# BULLETIN

From Atari Field Service

## FIREFOX

### Amplifone Raster Modification

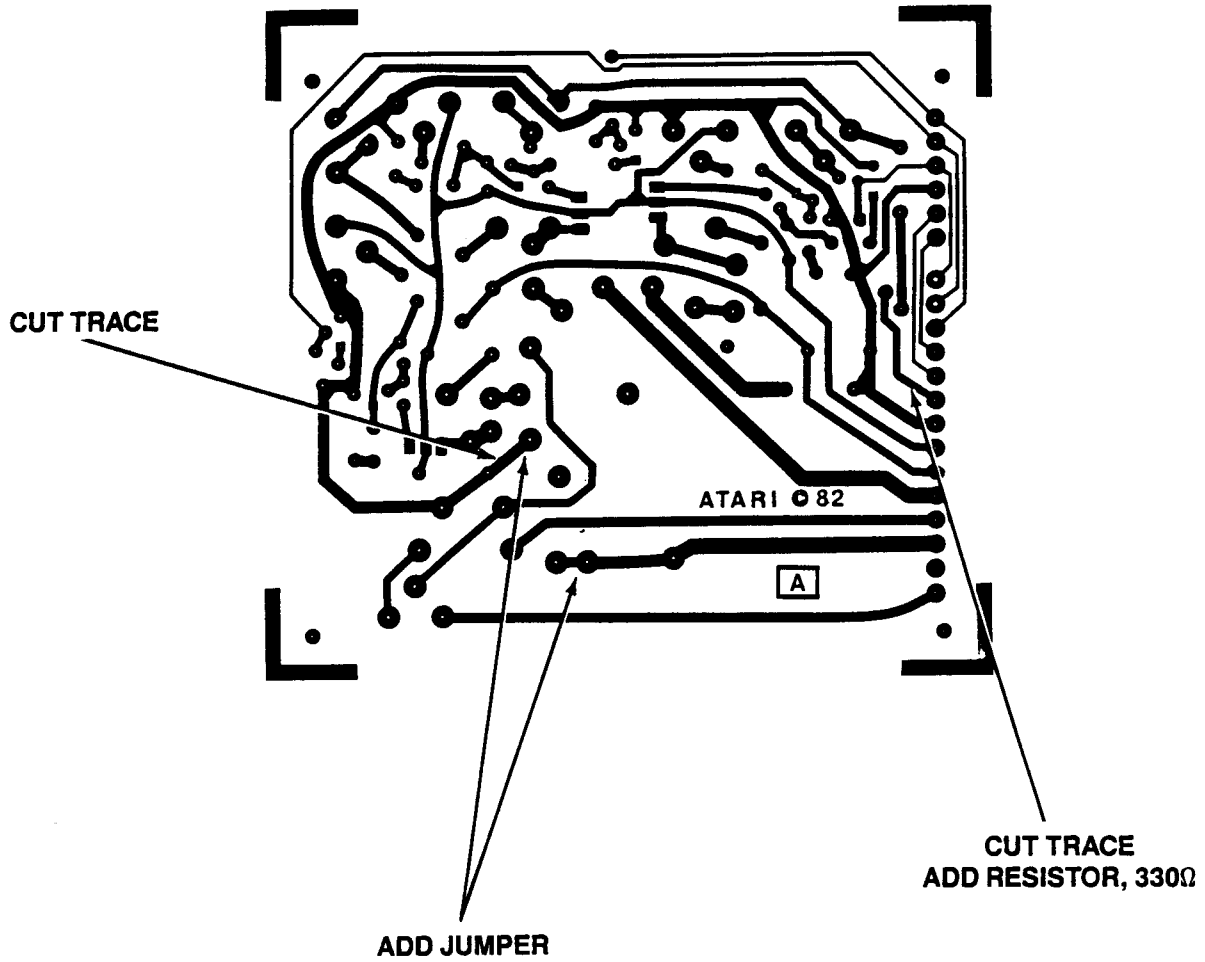
**4. Deflection Board**

Install a 1N751A zener diode (5.1 V) to the vertical sync input, anode to ground, as follows:

- a. Locate the first pad connected to J1 pin 5 on the trace or circuit side of the board. Note: PLL board is installed in place of J1.
- b. Locate the pad going to ground near J1 pin 6, between pin 6 and R10.
- c. Install the zener diode (anode to ground) between these two pads on the circuit side of the PCB.

- 5.**
  - a. Remove C5 (0.1  $\mu$ F) axial cap.
  - b. Install a 0.22  $\mu$ F (25 V) axial cap between the cathode and gate of Q4 (MCR101), soldering one lead of the cap to the cathode pad (square pad) of Q4 and the other lead to the pad of C5 connected to the gate of Q4. Install the cap on the circuit side of the PCB.

# Neck PCB Assembly

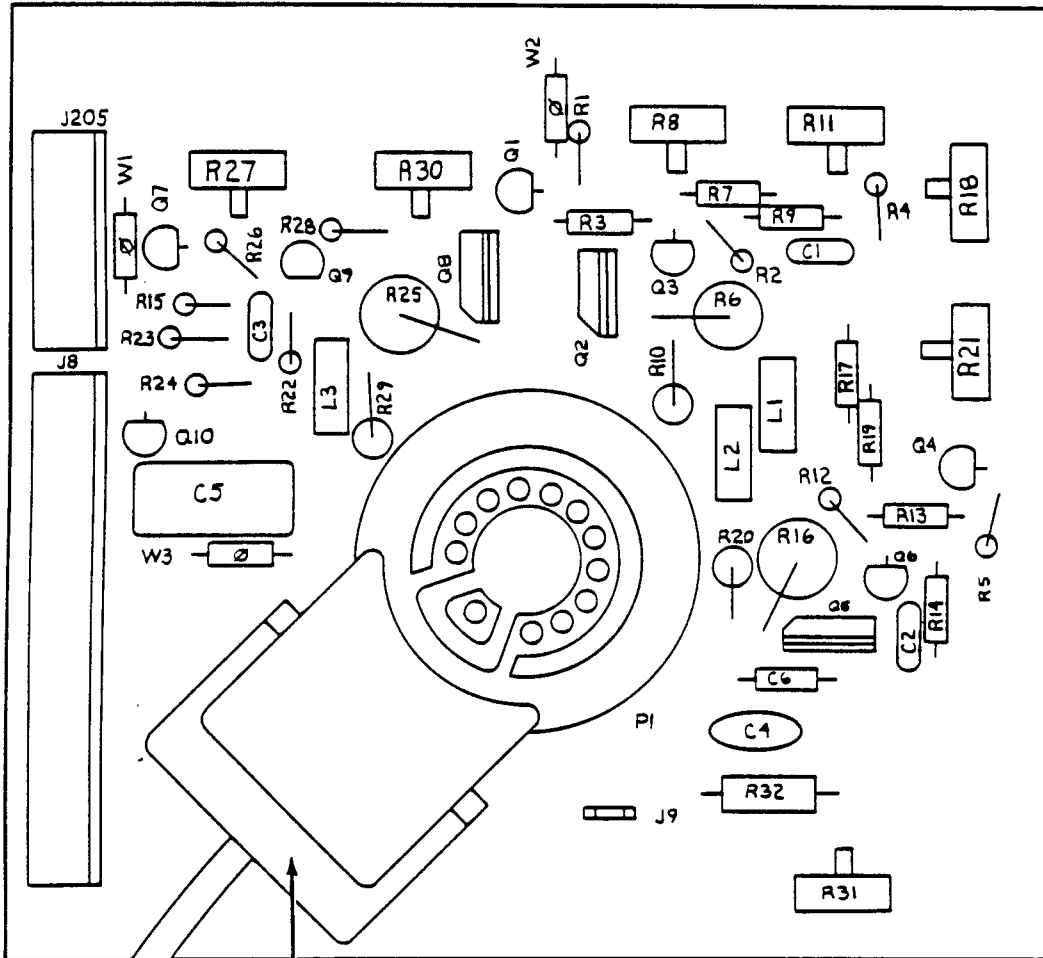
✓ **1. Neck Board**

Cut the trace between the pad at CRT socket pin 5 and the nearest pad. Install an insulated jumper (1000 volts or better insulation) between pad at CRT socket pin 5 and either of the pads at spade lug J9. Use a number 20 wire.

✓ **2.** Cut the trace between connector J8 pin 9 pad and the base pad of Q10. Install a 330 ohm,  $\pm 5\%$ ,  $\frac{1}{4}$  watt, resistor between the base of Q10 and the connector J8 pin 9 pad.

**FOCUS TERMINAL COVER**

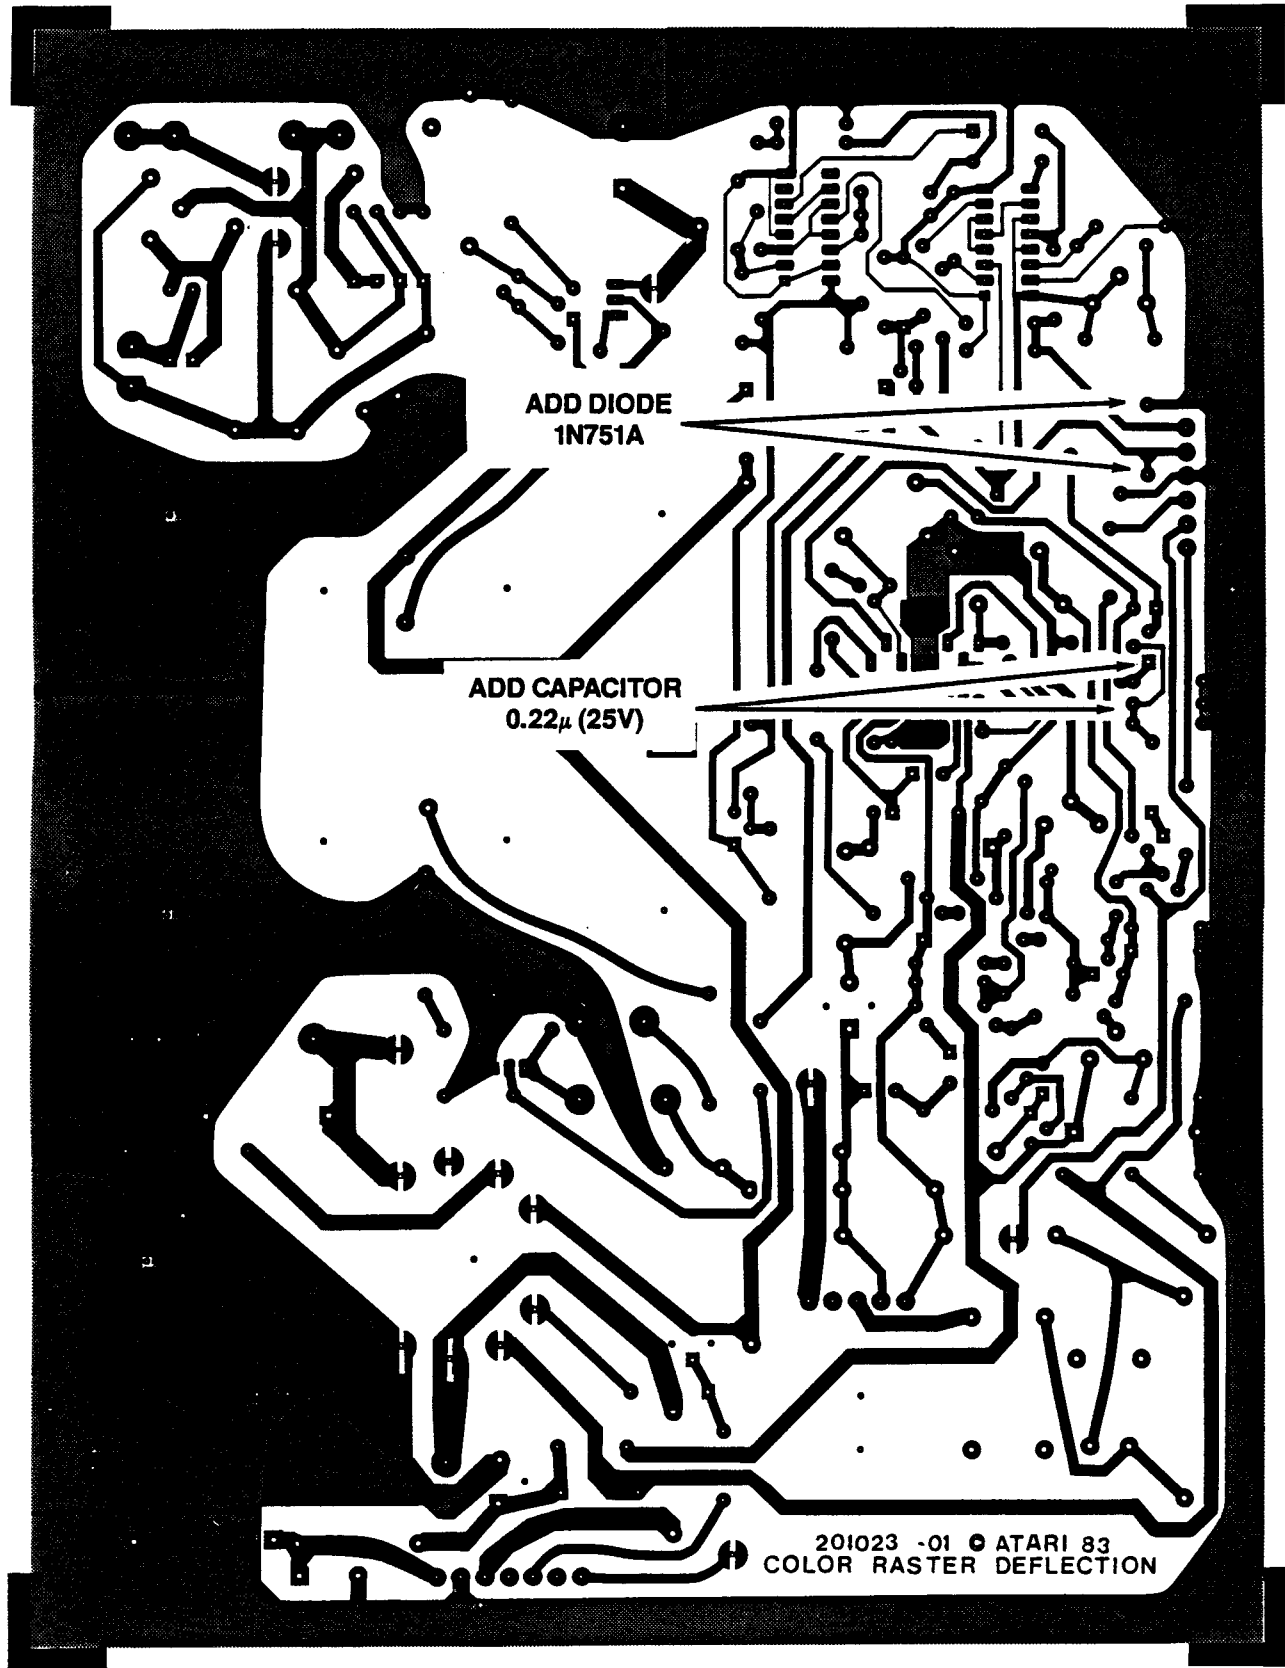
**3.** Remove the focus terminal cover from the CRT socket and unsolder the focus lead from the terminal. Solder a 22 meg-ohm,  $\pm 5\%$ ,  $\frac{1}{2}$  watt carbon-composition resistor to the terminal with the end flush with the terminal and resistor parallel to the board. Solder the focus lead flush with the other end of the resistor, and trim the resistor lead. Route the focus lead back to the exit groove, and replace the cover.
